DART SERVICE INSTRUCTION

TO AMEND INSTRUCTIONS FOR CONTINUED AIRWORTHINESS ICA-D350-600 REV. 4

REF. CANADIAN STC: SH93-88

SECTION 'L-L' UPPER HINGE ASSEMBLY

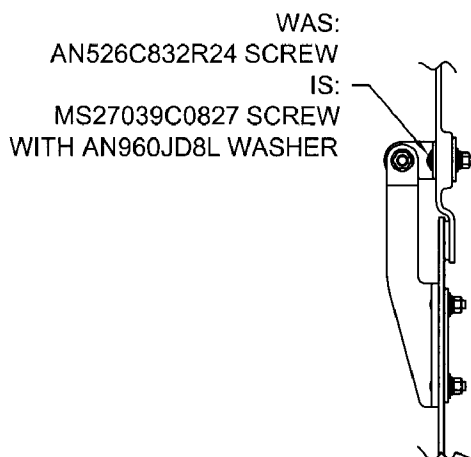
For the D350-600-241/-242 Spacepod™ Kits B/N 33438, 33439, 35395, 35396, 35397 and 35398, the AN526C832R24 screws that fasten the D3538-1 hinges to the Spacepod™ body have been replaced by MS27039C0827 screws with AN960JD8L washers. Section 'L-L' of Figure 10 should be updated as shown below.
